RE: ERIE AIR PARK TRACT E DRAINAGE REVIEW

We have reviewed the Erie Air Park Tract E submittal received on December 2, 2019. The submittal included Minor Subdivision Binder including Phase III Drainage Report for Lot E-2 Erie Air Park Tract E dated October 11, 2019 and Construction Plans (Area Grading and Utility) dated November 8, 2019, by Nassar Development. A Planned Unit Development (PUD) Binder also included a Conceptual Site Plan dated November 8, 2019 by Nassar Development. We have the following comments to offer:

ERIE AIR PARK TRACT E-2 *Replat D*

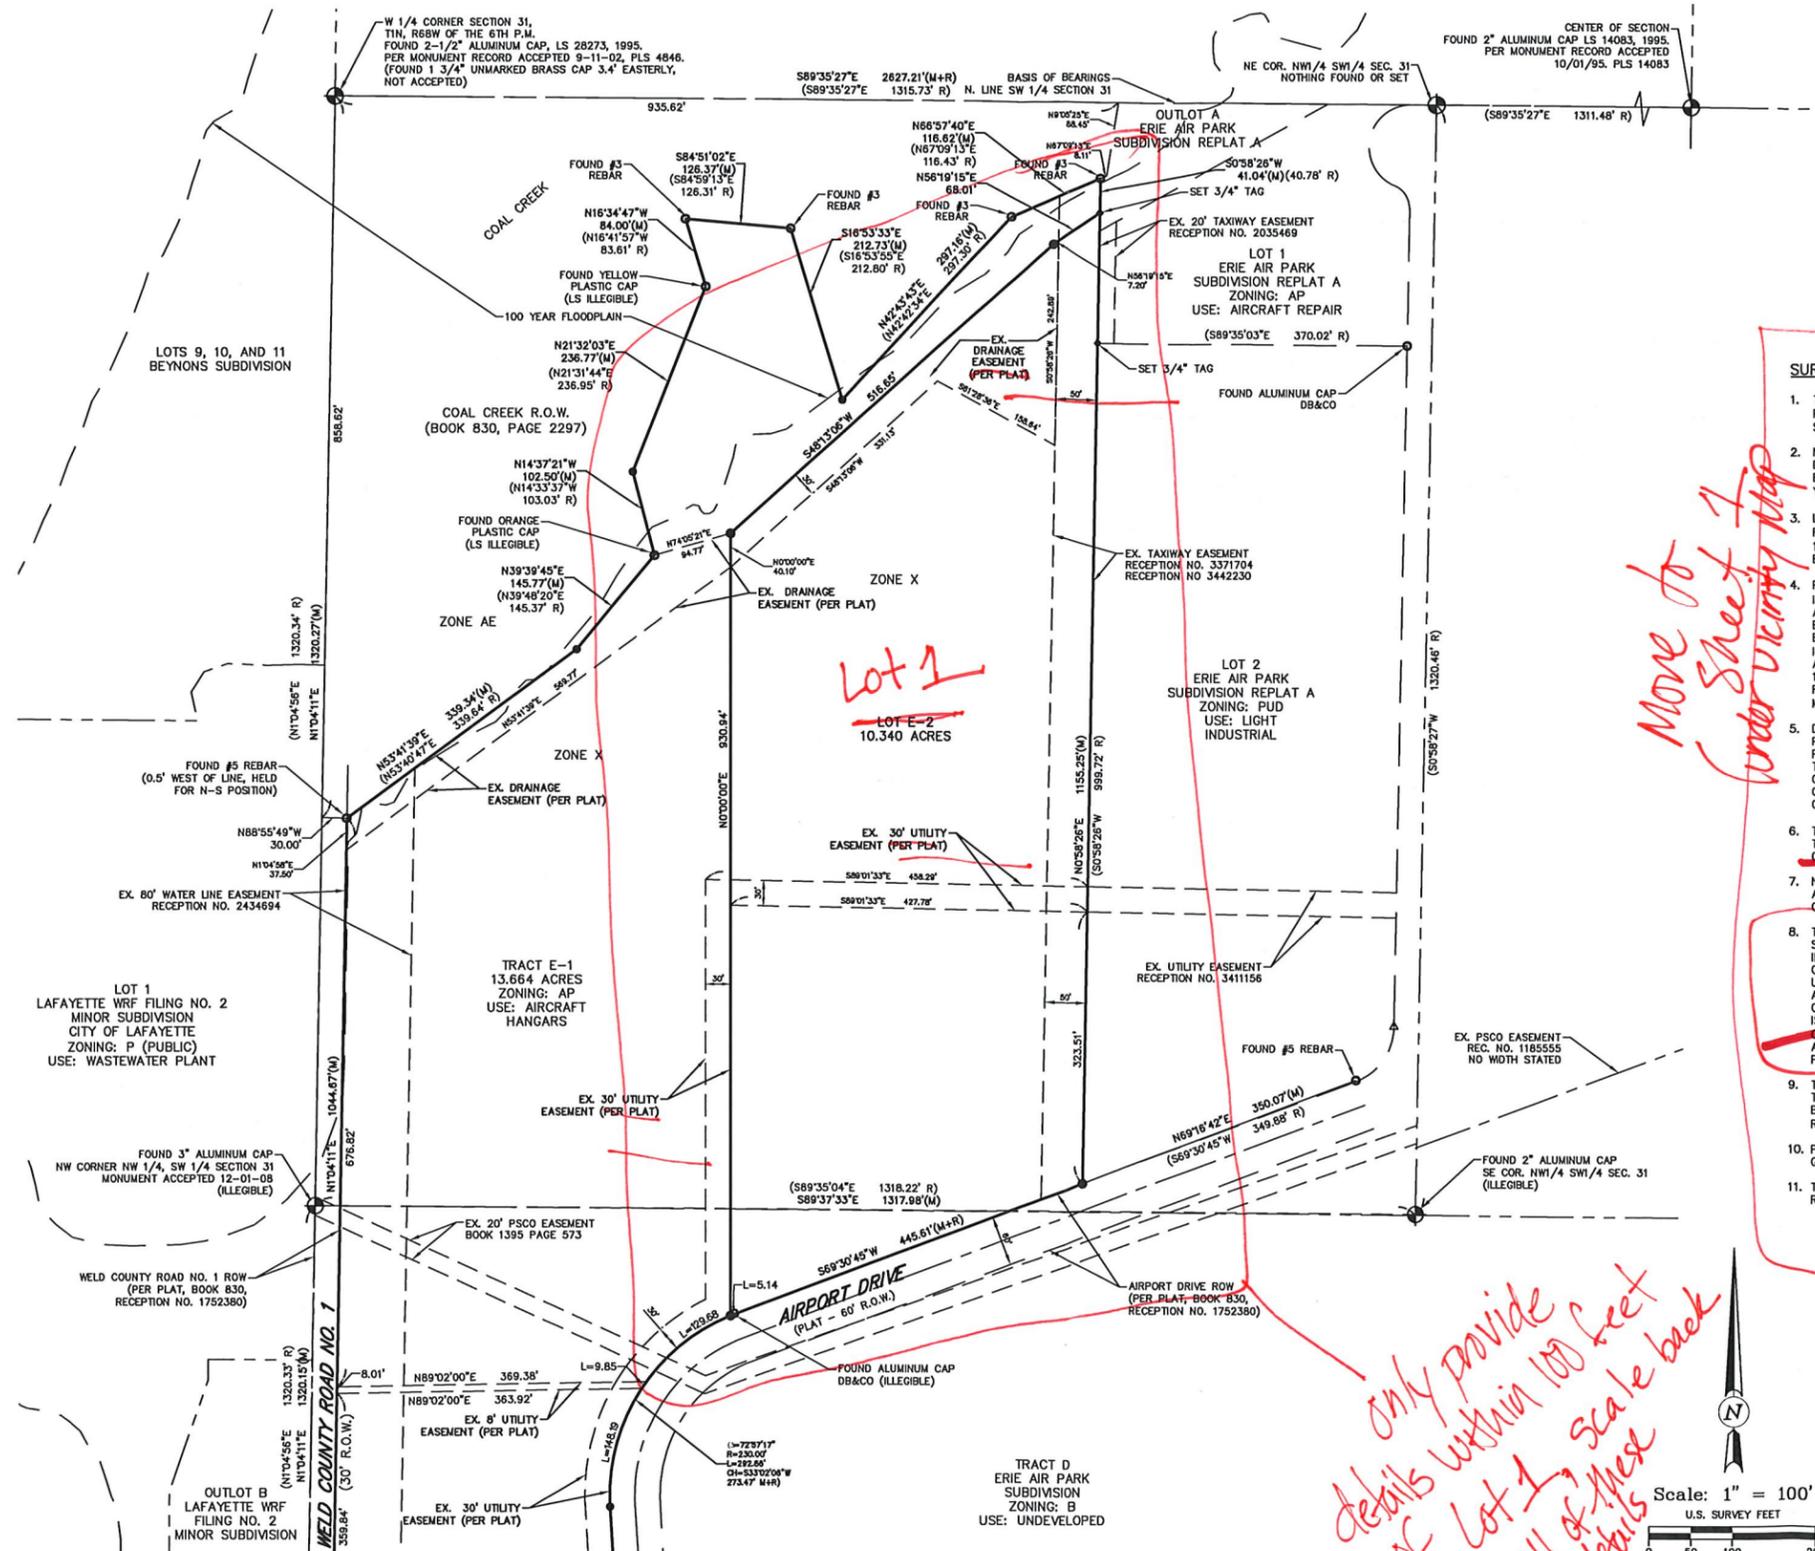
what easements are being dedicated by this plat? list in narrative and clearly show hereon

NOTES:
 ADD: Notice Note
 ADD: Basis of Bearing Statement
 ADD: Airport Influence Area note

*Move to
 Sheet 1
 under vicinity map*

*only provide
 details within 100 feet
 of Lot 1, scale back
 all of these
 details*

Sheet Title:
 ZONING MAP

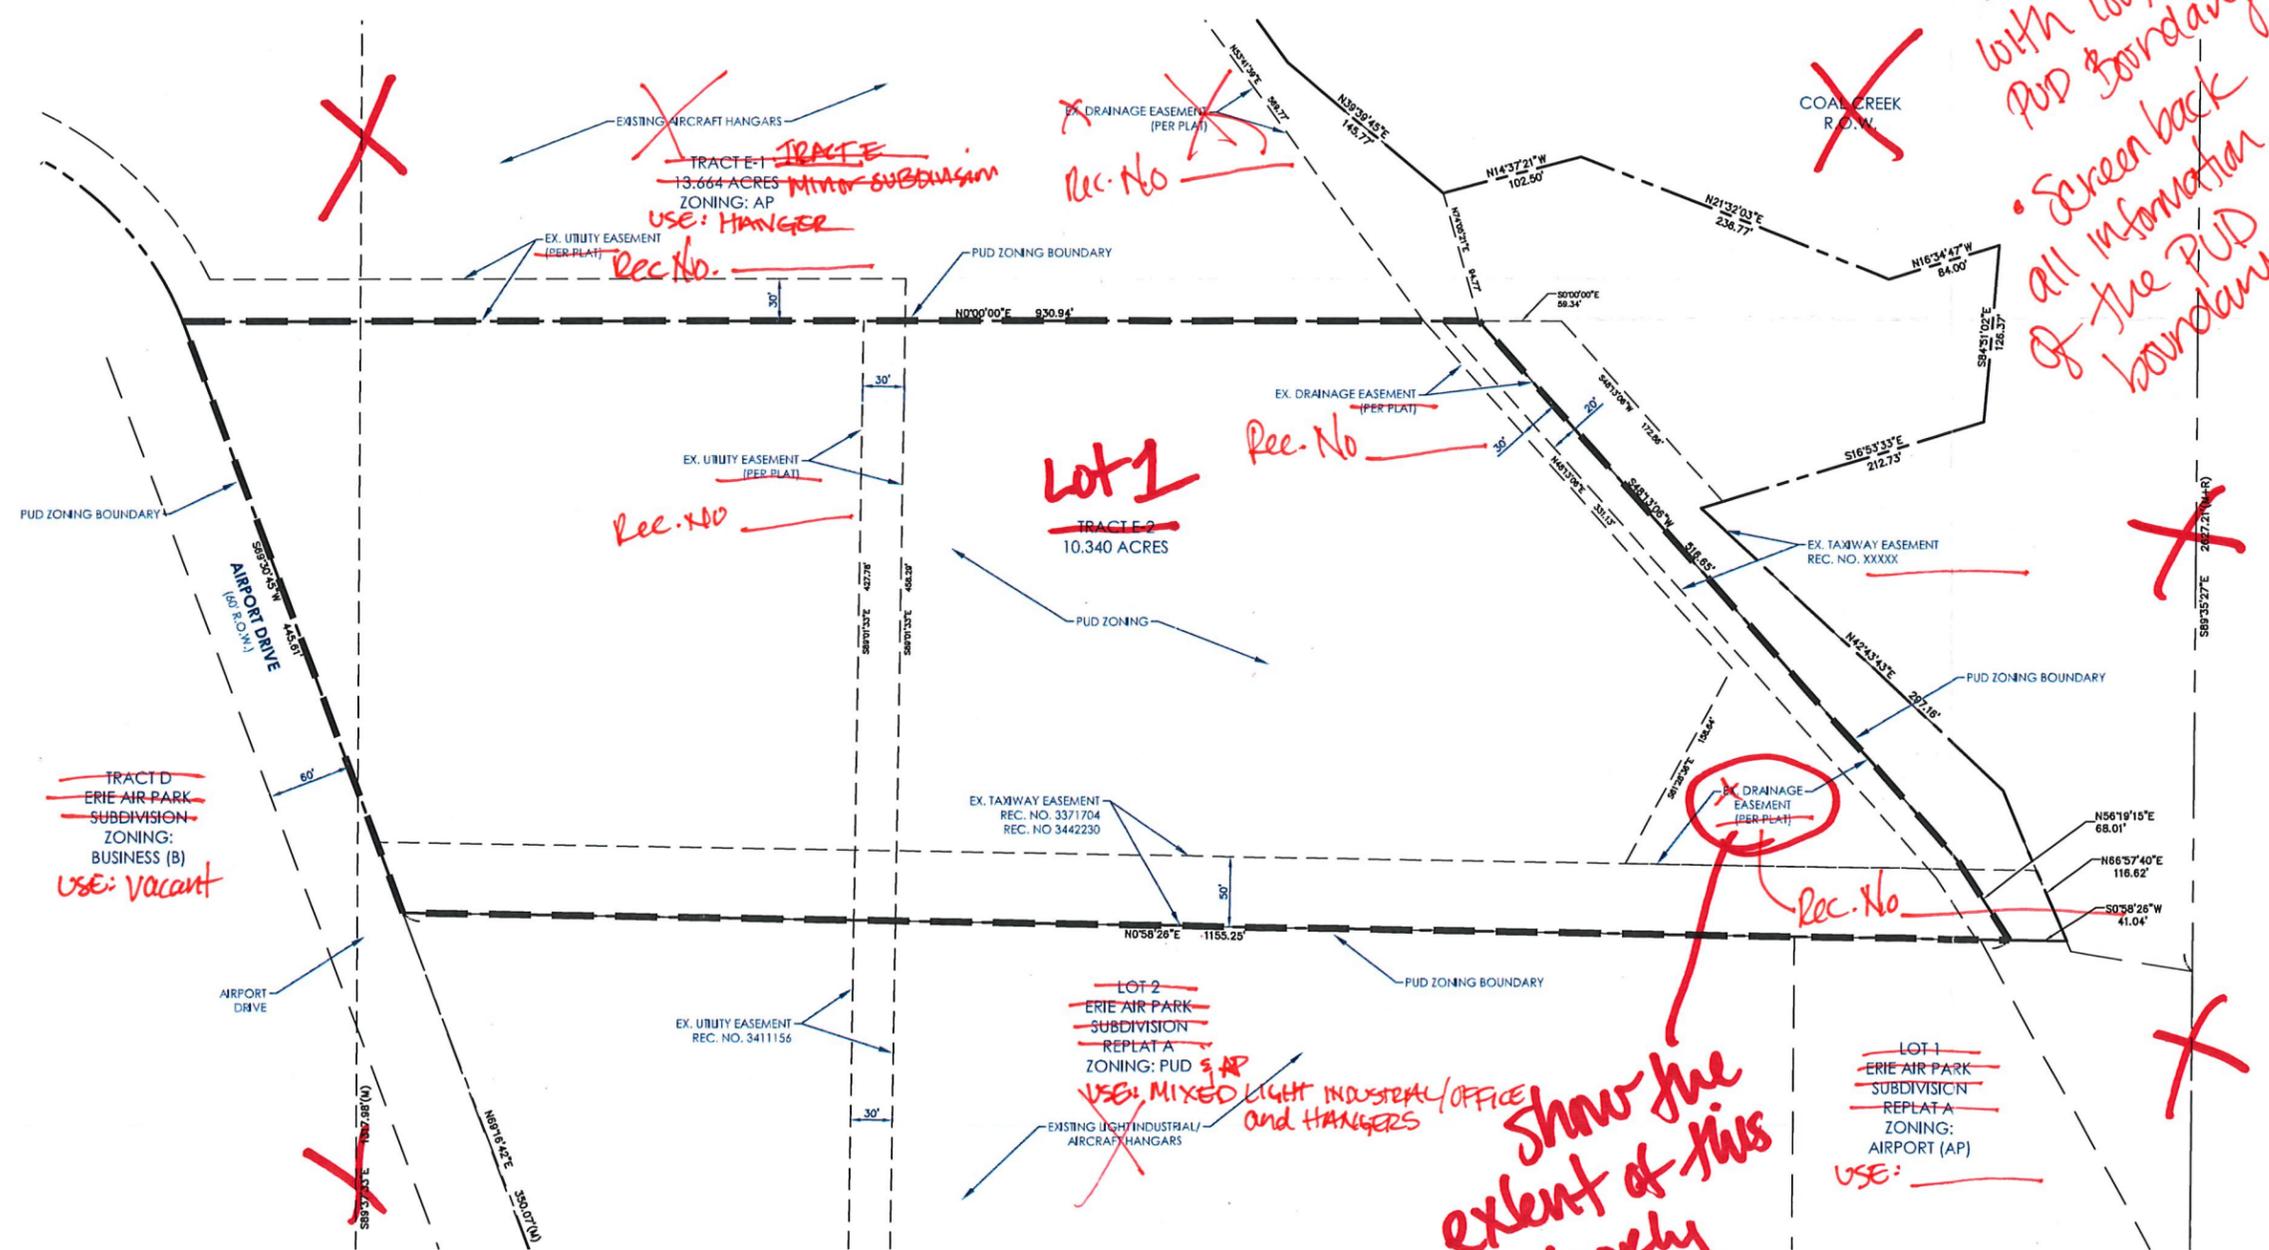
delete

Sheet Title:
COVER SHEET

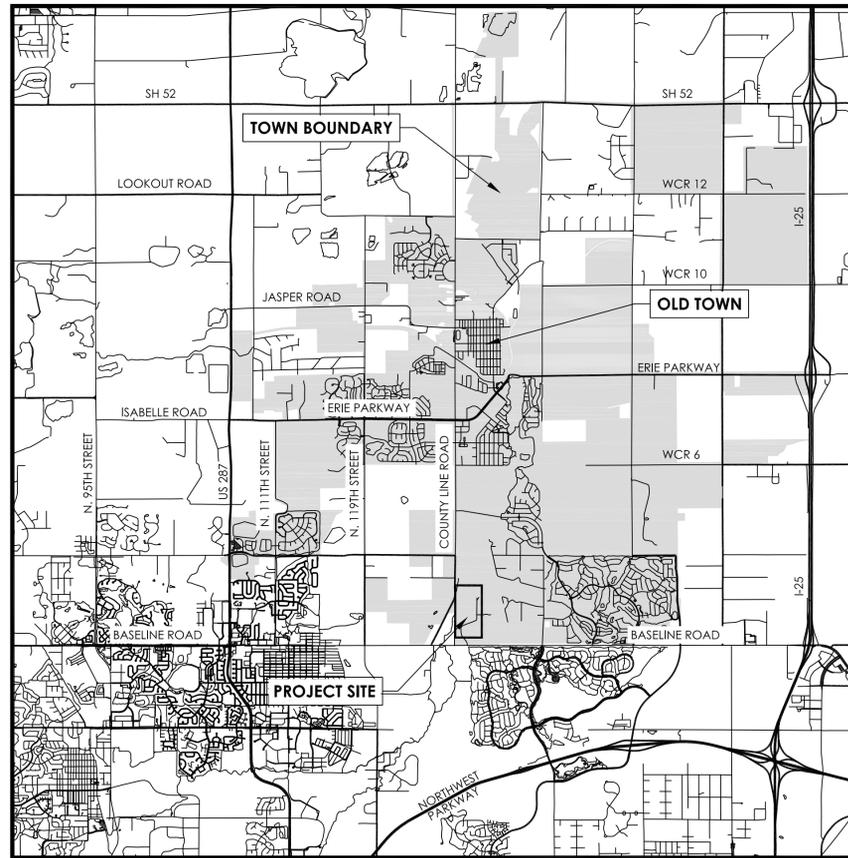
It says SW 1/4 on the plat. Correct either the plat or the PUD.

Add numbers.

Add a note stating: "In the event there is any discrepancy between the code and this PUD, the PUD shall control. Any provisions that are not specifically addressed in the approved PUD shall comply with the code."

A REPLAT OF TRACT E-2, ERIE AIR PARK SUBDIVISION TRACT E MINOR SUBDIVISION
 A PARCEL OF LAND LOCATED IN THE SW 1/4 OF SECTION 31
 TOWNSHIP 1 NORTH, RANGE 68 WEST OF THE 6TH P.M.
 TOWN OF ERIE, COUNTY OF WELD, STATE OF COLORADO
 10.340 ACRES - 1 LOT
 MS-001121-2019

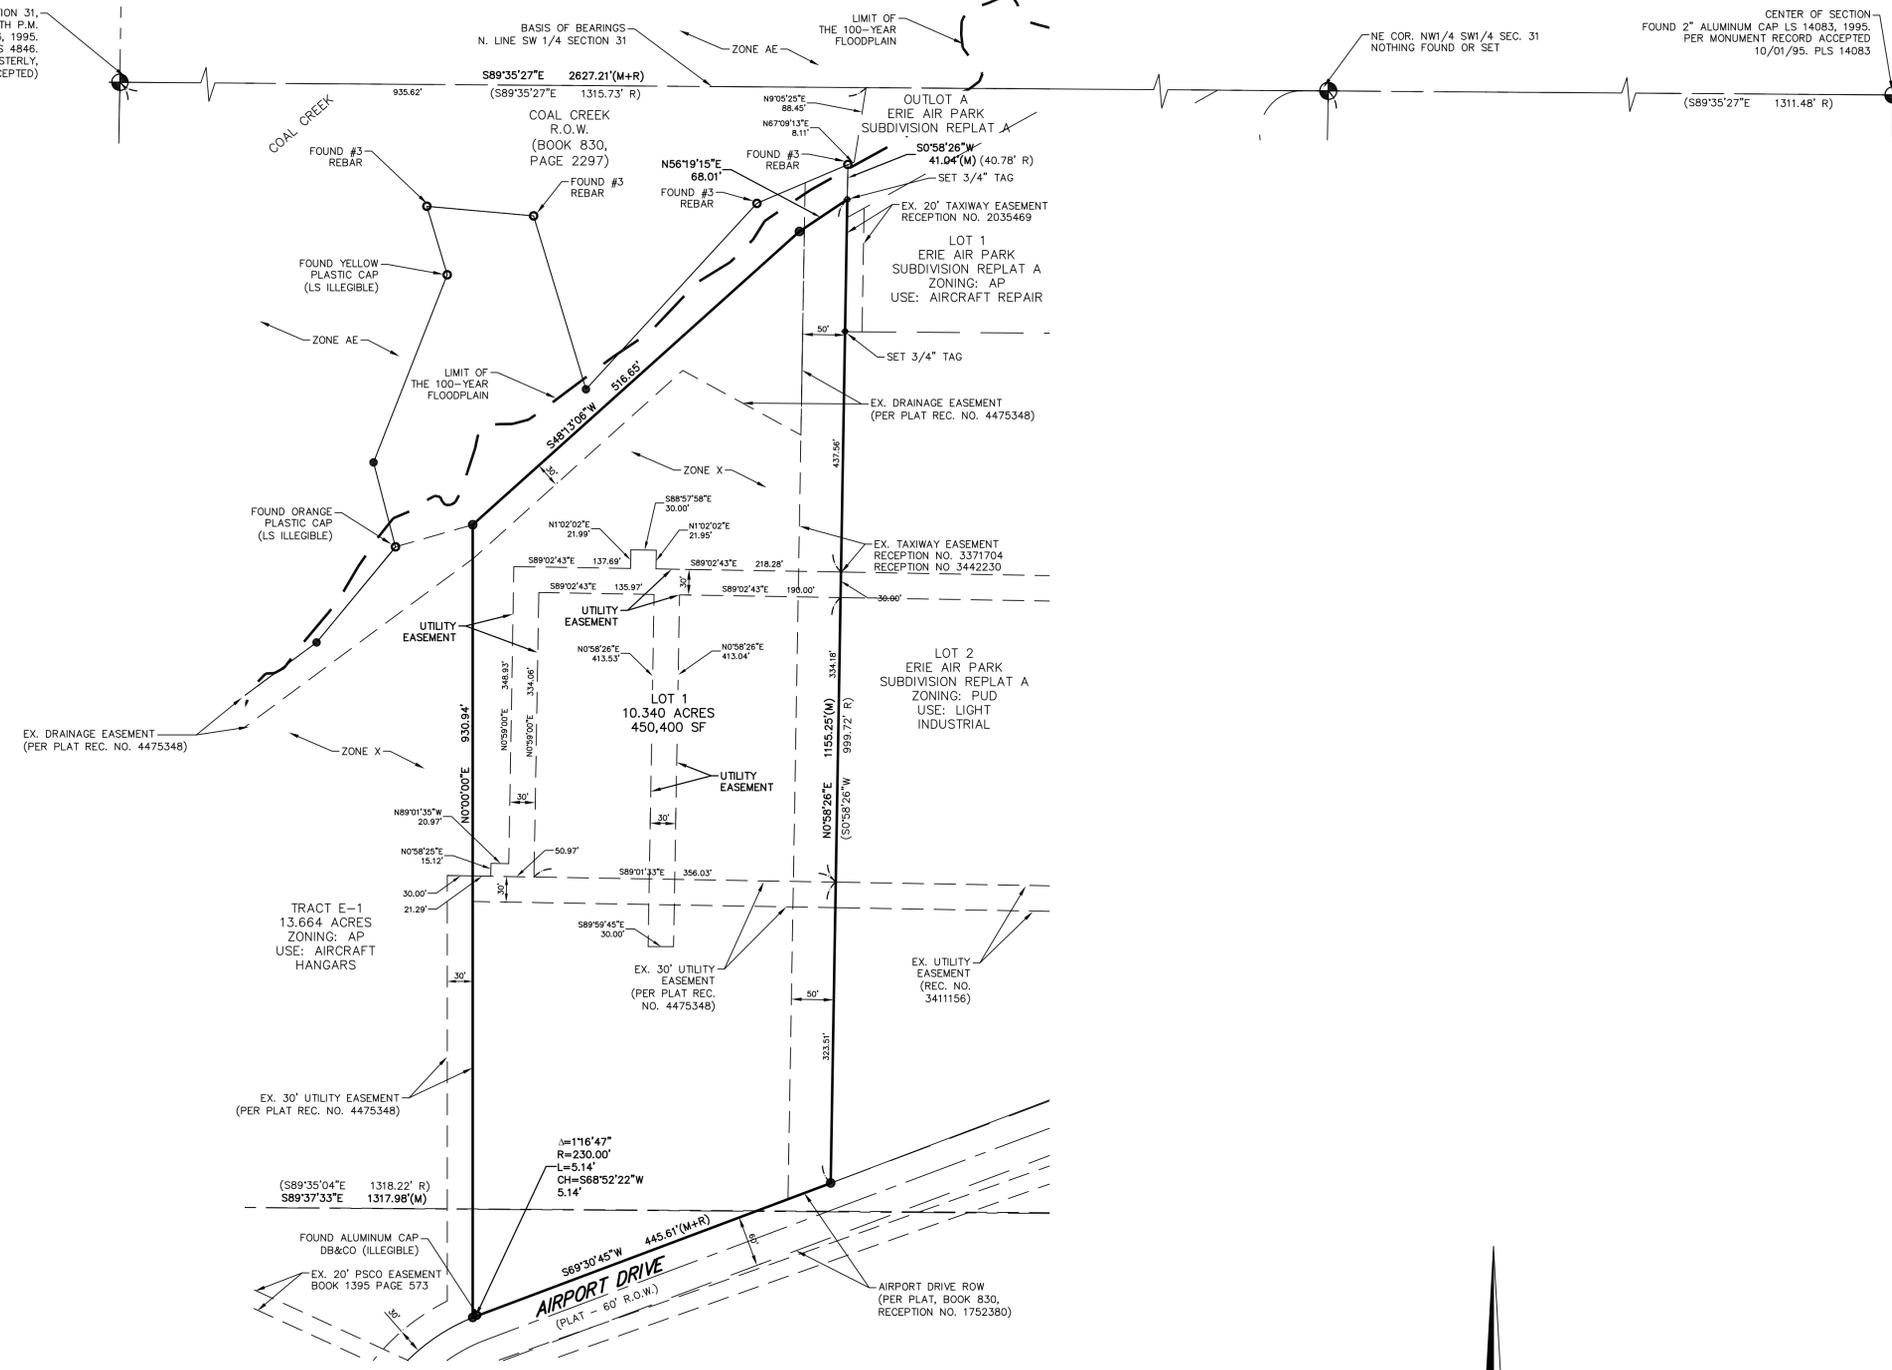
This description needs describe the lot now, not what it will be. "Erie Airpark Tract E Minor Subdivision"
